Re: Docket No. 516 – The United Illuminating Company Application for a Certificate of Environmental Compatibility and Public Need for the Fairfield to Congress Railroad Transmission Line 115-kV Rebuild Project

Enclosed for filing with the Connecticut Siting Council (“Council”) is The United Illuminating Company’s responses to the Council’s May 10, 2023 interrogatories (Set One).

Interrogatory CSC-1

Figure 9R. Magnetic-field level at 79 Unquowa Place compared to the ICNIRP limit of 2,000 mG.

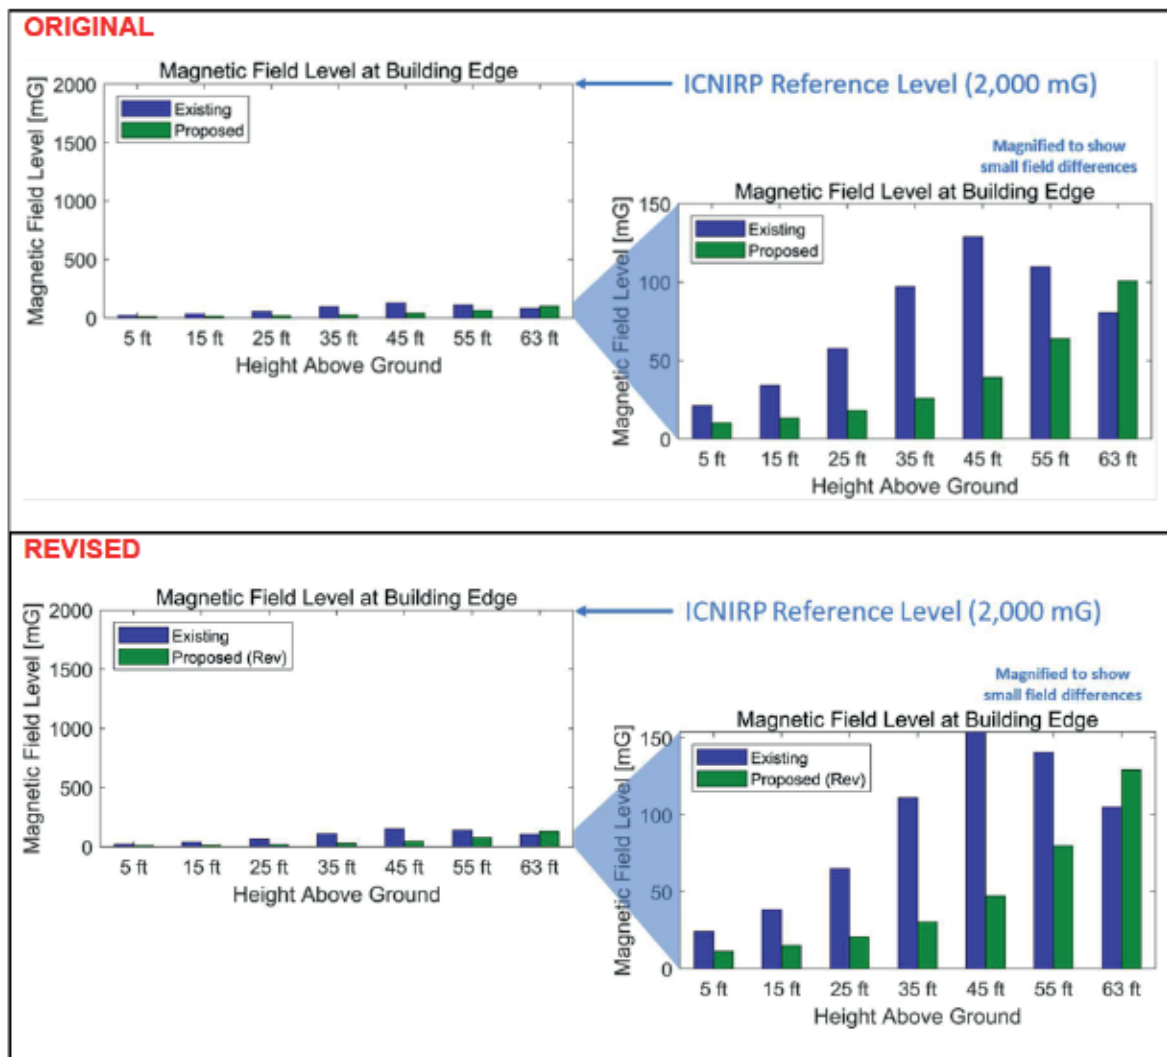
For instance, as shown in Figure 9R at average loading and a height of 45 feet above ground, the existing magnetic field is calculated to be the highest. This corresponds to the height of the existing conductors (which are between 42 and 48-52 feet) and the magnetic field is calculated to decrease from 129-154 mG to 39-47 mG for the proposed configuration. At the roof of the building, magnetic-field levels are calculated to increase from 80-105 to 101-129 mG at the front edge of the building. Similar to all other locations along the route, magnetic-field levels decrease rapidly with distance and at the back end of the building, magnetic-field levels are calculated to be less than 3 mG before and after the proposed Project. Although before and after the Project, all EMF levels at the apartment building are calculated to be far below guideline levels established by ICNIRP or the ICES, UI is evaluating the viability of alternative designs for the rebuilt line at this location. Additional analysis is provided in Attachment E.

The revised calculations show that the magnetic fields levels before and after the project will be quite similar. Both the original and revised calculations decrease in magnetic field levels at all heights above ground except at the roof

Figure 10R. Magnetic-field levels at the apartment building in Bridgeport (at a height of 1 meter [3.28 ft] above ground) compared to the ICNIRP limit of 2,000 mG.

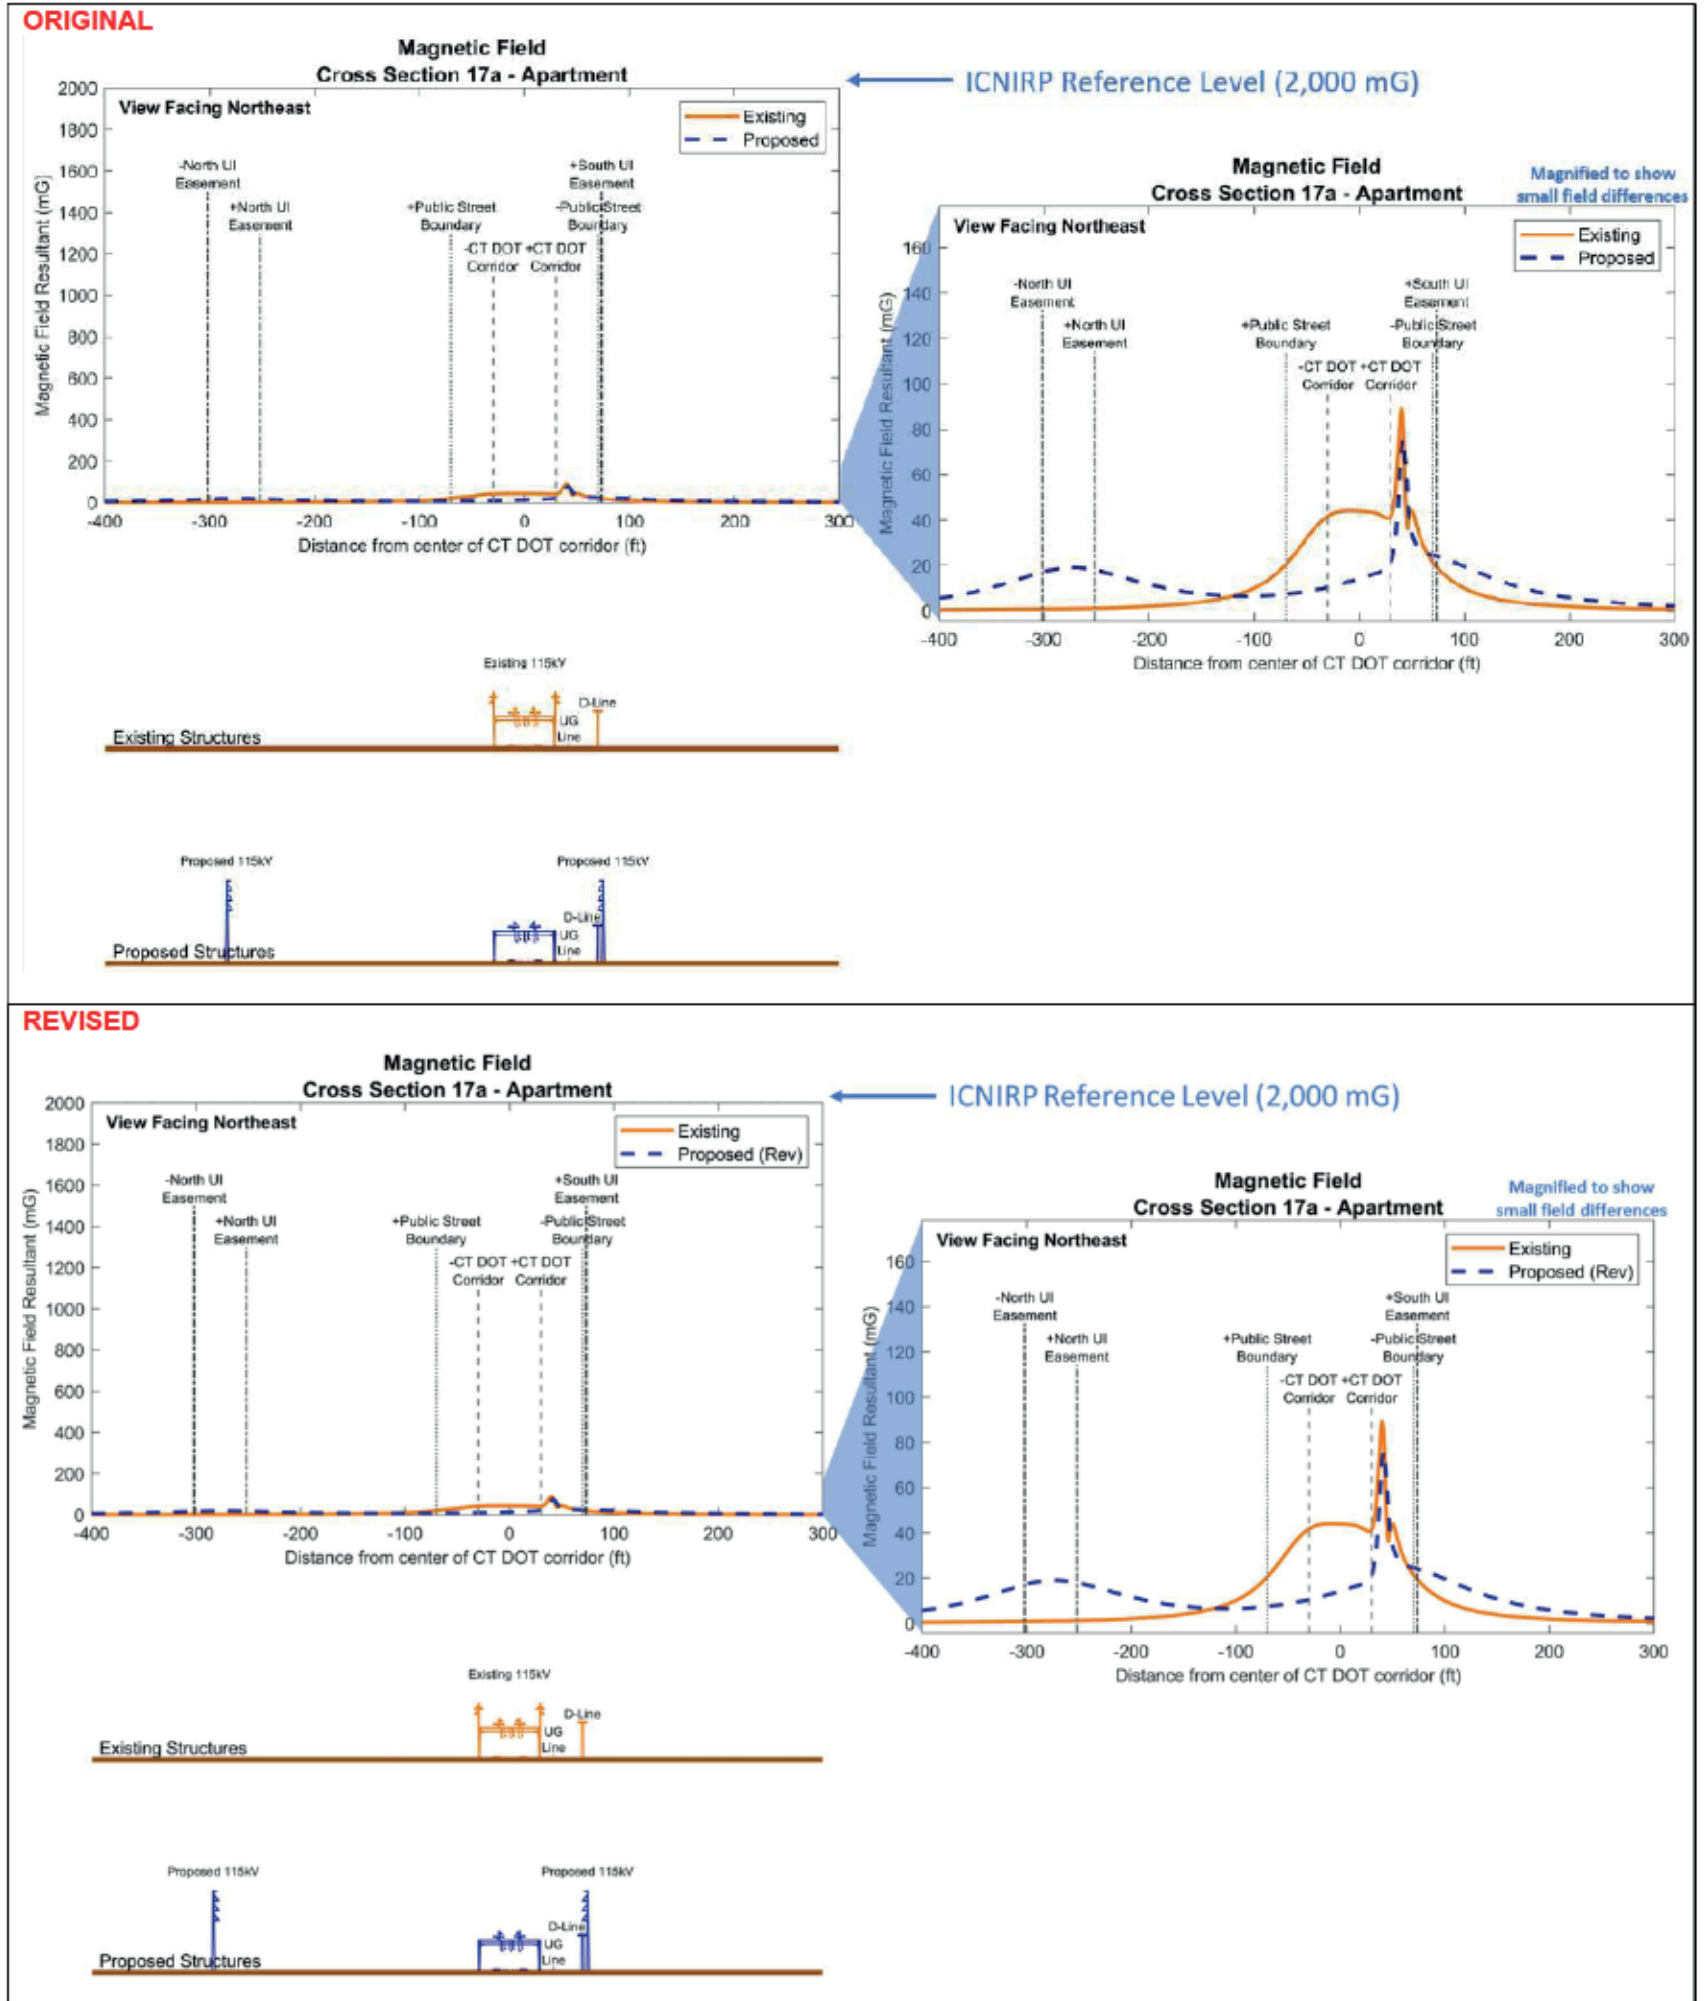
In the area north of the CT DOT corridor in XS-17, UI identified two residential buildings. These buildings are shown by the blue square in Figure 8 and applicable magnetic-field modeling results are shown on the left side of Figure 10R (i.e., the north side of the CT DOT corridor). North of the CT DOT corridor, along West Avenue between the CT DOT corridor and the new proposed permanent UI easements along South Frontage Road, there is one residence where the magnetic-field level is calculated to increase by approximately ~~13~~-6.4 mG to ~~17~~-11 mG (depending on the location within the building). One additional building, located at the intersection of West Avenue and Railroad Avenue within a mixed development zoning designation, is used for both residential and commercial purposes. At this building the magnetic-field level is calculated to decrease by approximately ~~3~~-12 mG or increase by up to approximately ~~5~~-1.6 mG (depending upon the location within the building). Before and after the Project, all EMF levels at these buildings are calculated to be far below guideline levels established by ICNIRP and ICES.

Figure 11R. Magnetic-field level at the Windward apartment building near the intersection of Railroad Avenue and Park Avenue in Bridgeport compared to the ICNIRP limit of 2,000 mG.

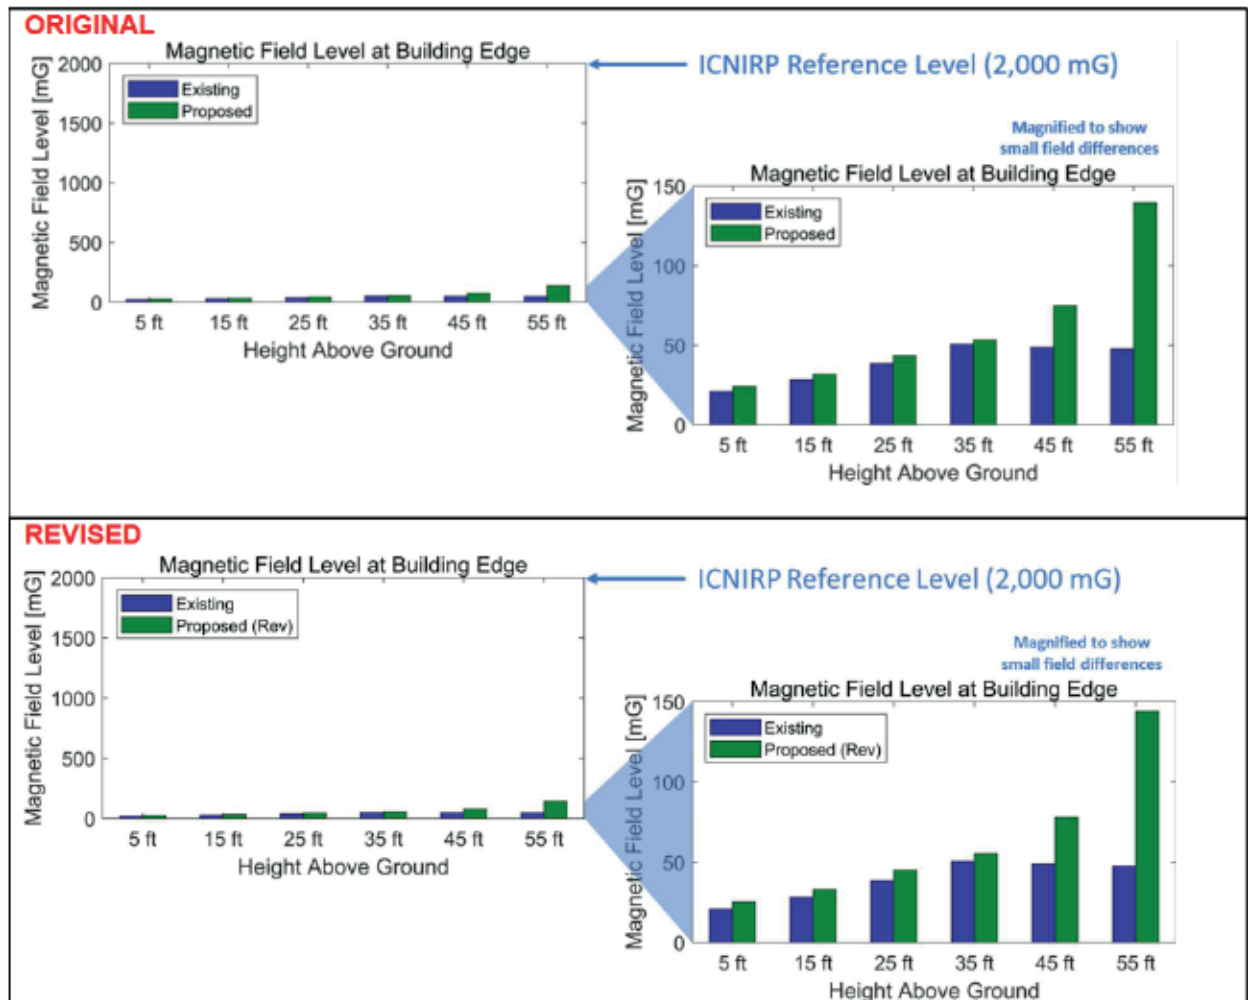
Additional analysis, shown in Figure 11R, presents results of the existing and proposed magnetic-field levels at the front edge of the building (closest to the transmission lines) at greater heights above ground and at average loading. In this figure the magnetic-field level at every 5 feet above ground is shown for both existing (blue bars) and proposed (green bars) configurations. The net result of this change is that magnetic-field levels at the front edge of the building (closest to the transmission lines) are calculated to increase slightly as a result of the Project up to a height of about 35 feet, and then to increase more substantially at greater heights above ground, with the maximum increase at the roof of the building.

The revised calculations still show that the magnetic fields levels before and after the project will be quite similar. Both the original and revised calculations show higher magnetic field, with the greatest change at heights above 45 feet.

Figure 1. Magnetic-field level (mG) at a height of 1 m (3.28 ft) above ground at 79 Unquowa Place compared to the ICNIRP limit of 2,000 mG.

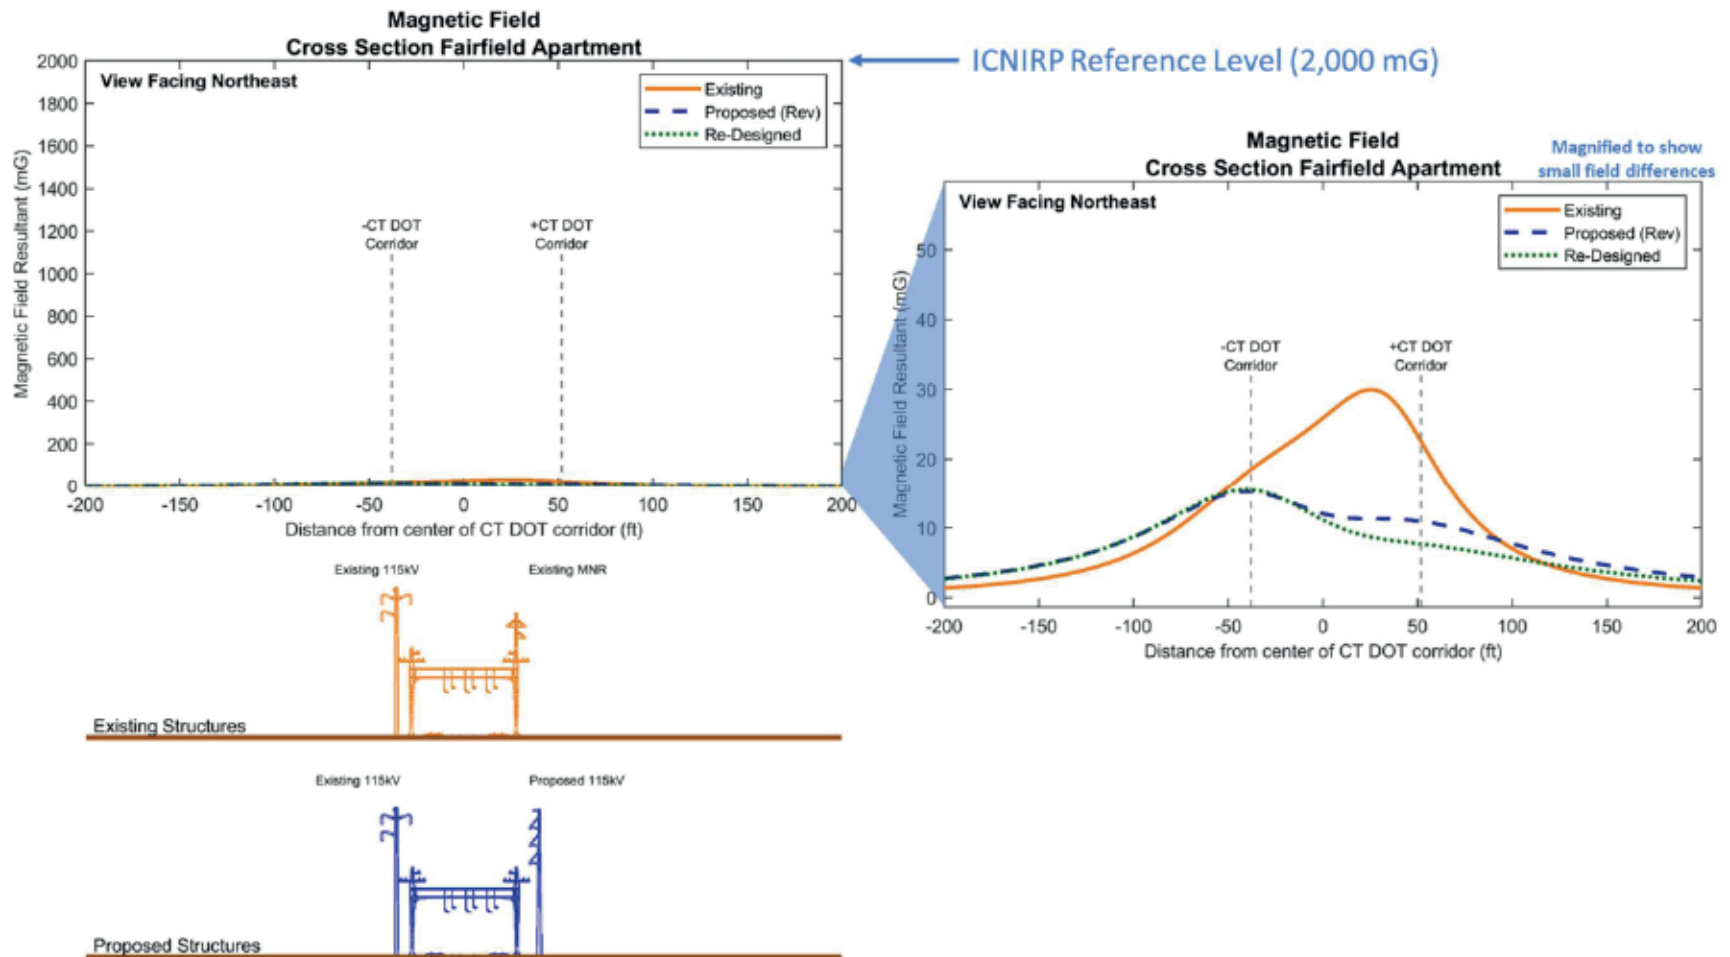
Figure 1 illustrates the result of the redesign at a height of 1 meter (m) (3.28 ft) above ground referenced to the edges of the CT DOT corridor, providing a visual summary of the calculated magnetic field, along with representations of the existing and proposed structures, and compares these values to ICNIRP limits on magnetic fields. On the north side of the ROW, there is a negligible change in the magnetic-field level as a result of the redesign. On the south side of the ROW, at the closest portion of the apartment building (near the southern CT DOT corridor boundary), the redesign results in a magnetic-field reduction of approximately 30%.

Figure 2. Magnetic-field level at average loading at the building edge of 79 Unquowa Place compared to the ICNIRP limit of 2,000 mG.

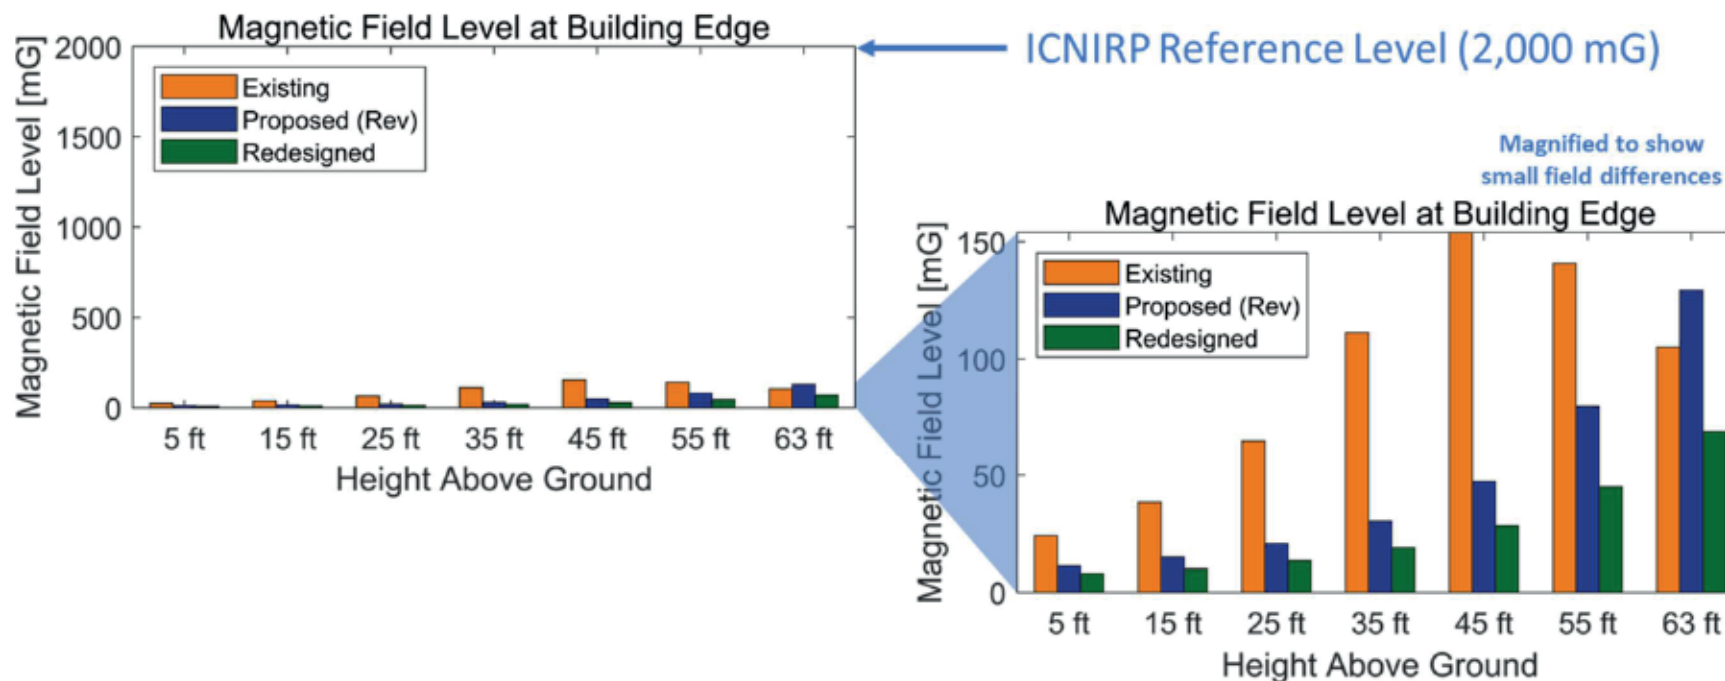
Results of the magnetic-field level calculations *at the front edge of the building* (closest to the transmission lines) at average loading are shown in Figure 2. In this figure the magnetic-field level at every 5 ft above ground is shown for the existing configuration (orange bars), proposed (revised) configuration (blue bars), and redesigned configuration (green bars). The redesigned configuration results in a decrease in magnetic-field levels at the front edge of the building (closest to the transmission lines) at all stories of the building, including at the roof.⁸

As shown in Figure 2, at average loading and a height of 45 ft above ground, the existing magnetic field is calculated to be the highest. This corresponds to the height of the existing conductors (which are between 42 and 52 ft). At this height, the magnetic field is calculated to decrease from 154 milligauss (mG) for the existing configuration to 47 mG for the proposed (revised) configuration, and to 28 mG for the redesigned configuration. At the roof of the building, the existing magnetic-field level (105 mG) would increase to 129 mG for the proposed (revised) configuration, but would decrease to 69 mG for the redesigned configuration. Similar to all other locations along the route, magnetic-field levels decrease rapidly with distance, and at the back end of the building, magnetic-field levels are calculated to be less than 3 mG for any of the existing, proposed (revised), or redesigned configurations.

Further analysis of the data in Figure 2 shows that the redesigned configuration results in a 30% to 47% decrease in magnetic-field levels compared to the proposed (revised) configuration. The largest percent decrease is at the roof where, as described above, the calculated magnetic-field level would decrease from 129 mG to 69 mG (a 47% decrease). The results of similar calculations at peak loading are shown in Figure 3.
